SITE ASSESSMENT REPORT ADDENDUM FOR BUILDING 860 TANKS 860 A/B/D NAS CECIL FIELD FL

Site Assessment Report Addendum for Building 860, Tanks 860 A/B/D

Naval Air Station Cecil Field

Revision 0
03/15/01

Figure 2-1
Soil Excavation Area
Building 860 Source Removal Report
NAS Cecil Field, Florida

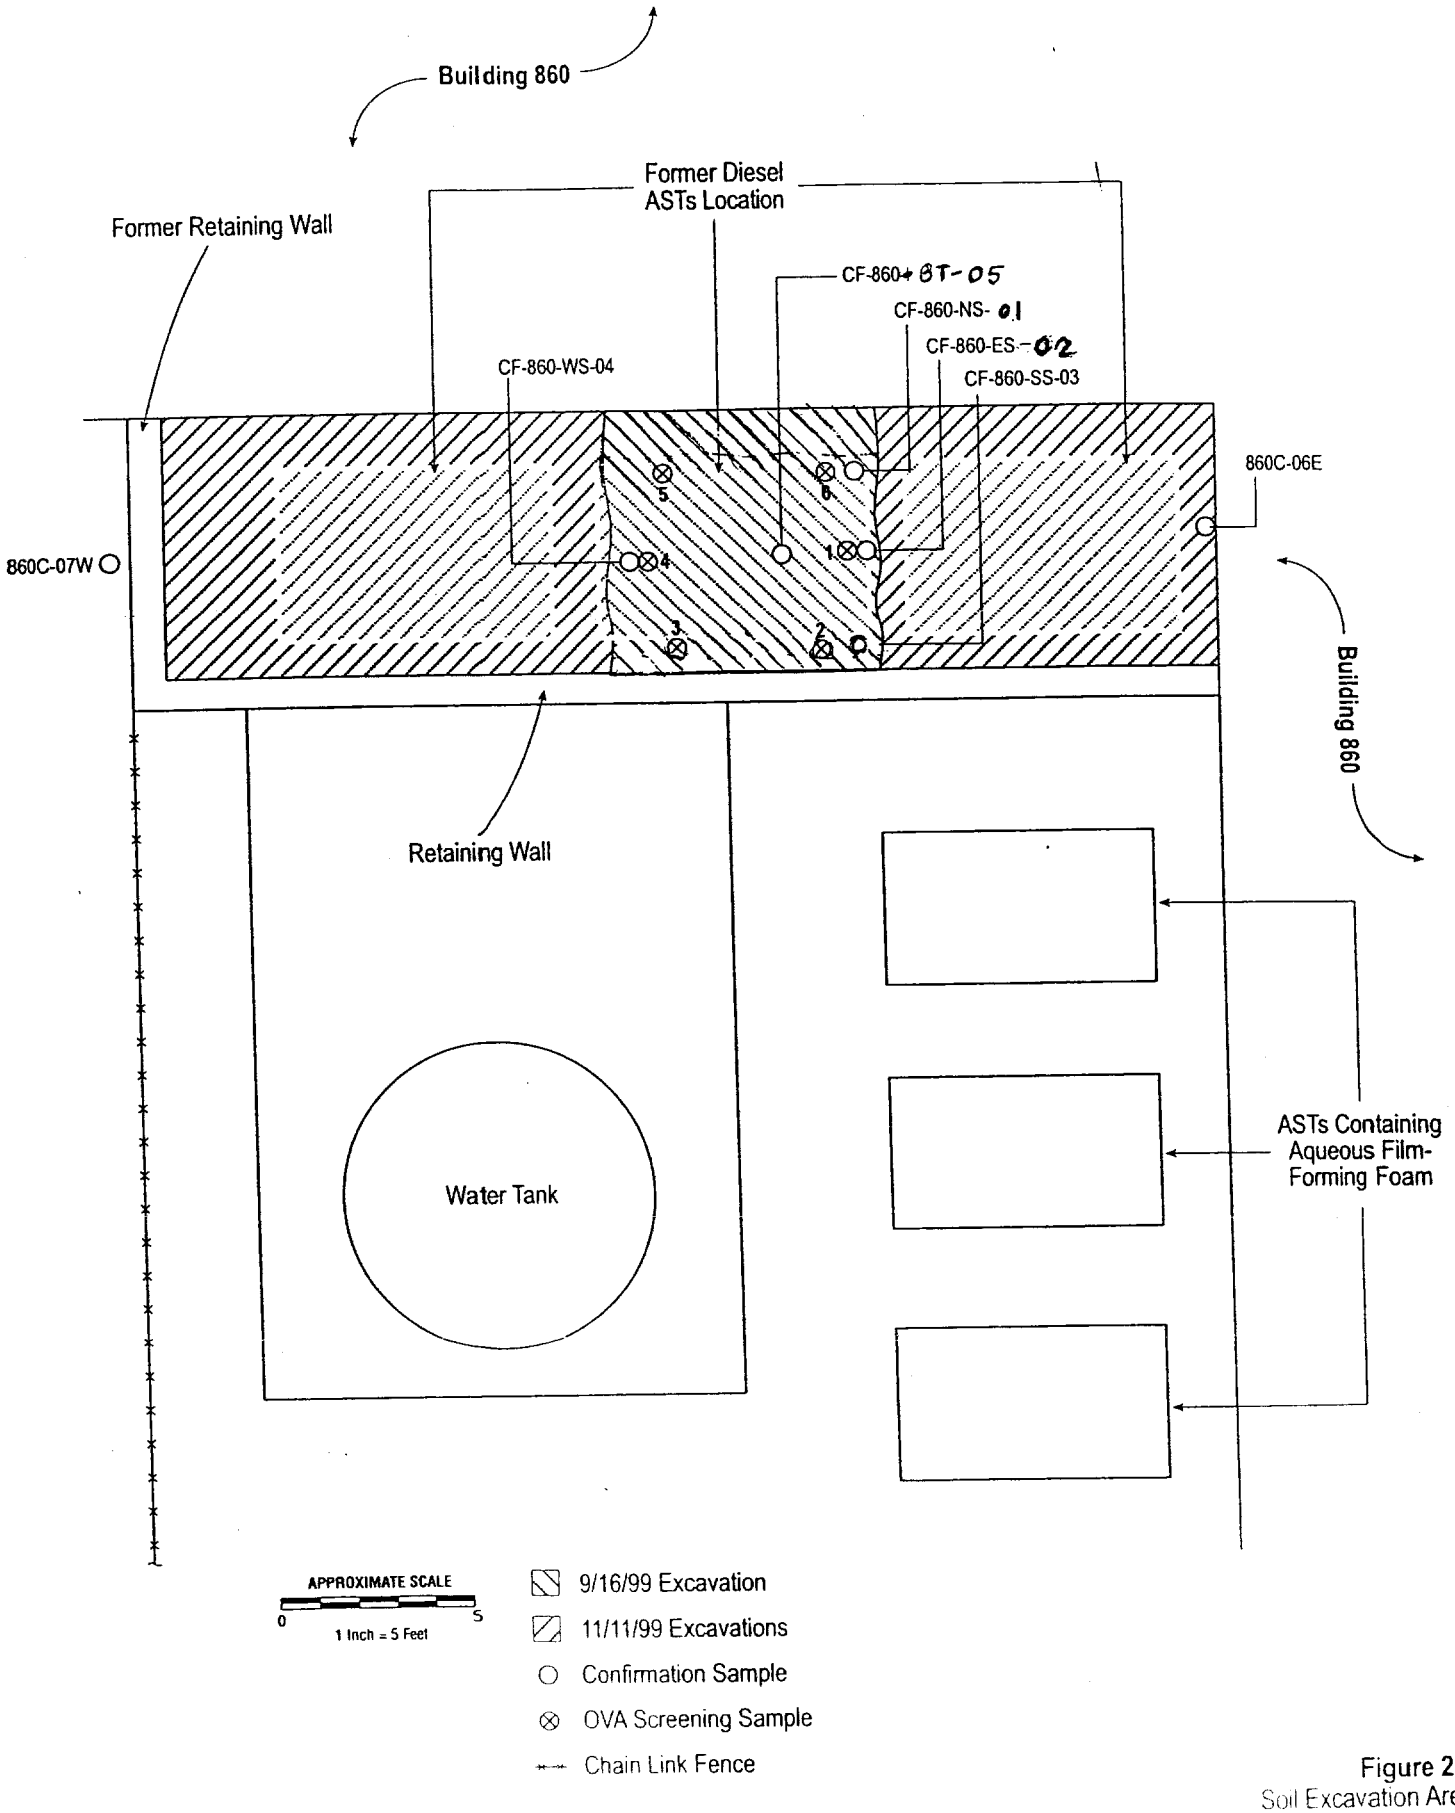
Attached is a revised Figure 2-1 for the referenced document. Please remove the original Figure 2-1 from the document and replace it with this version. As discussed, the original Figure 2-1 was revised based upon a review of field notes and sketches that indicated that the excavation boundaries were drawn incorrectly.

CH2MHill submitted the revision to the SRR on November 29, 2000 (CH2MHill, 2000b). This revision consisted of a revised Figure 2-1 that shows the excavation limits and soil sample locations. (See Appendix A.) CH2MHill also indicated that the limits of the excavation to the north and east were the building walls and to the south and west were the containment walls. CH2MHill also reported that all walls were scraped clean of soil. Thus, the only remaining soil sample locations with concentrations greater than SCTLs were from the bottom of the excavation at the water table and outside the excavation to the west.

The first sample location (CF-860-BT-05) that was not excavated was collected at about 8 feet below ground surface (bgs). TtNUS reported the depth to water in the former AST area (TtNUS, 2000) to be about 7.5 feet bgs. Therefore, TtNUS concurs with stopping the excavation at a depth of about 8 feet bgs. During the excavation by CH2M Hill, they discovered that the building and exterior walls surrounding the former AST area have sides and footings that extend continuously to about 8 feet bgs. The original SRR (CH2MHill, 2000a) indicated that all soil within the limits of the walls and footings (Figure 2-1 of Appendix A) was removed down to about 8 feet bgs.

The second soil sample (860C-07 W) is indicated in the figure in Appendix A to lie outside the walls that bound the former AST area. Since that sample did not exceed the SCTL for leachability to groundwater, CH2MHill considered the soil in that area (which is outside the walls that bound the former AST area) to be non-impacted by petroleum contamination and did not proceed with further excavation.
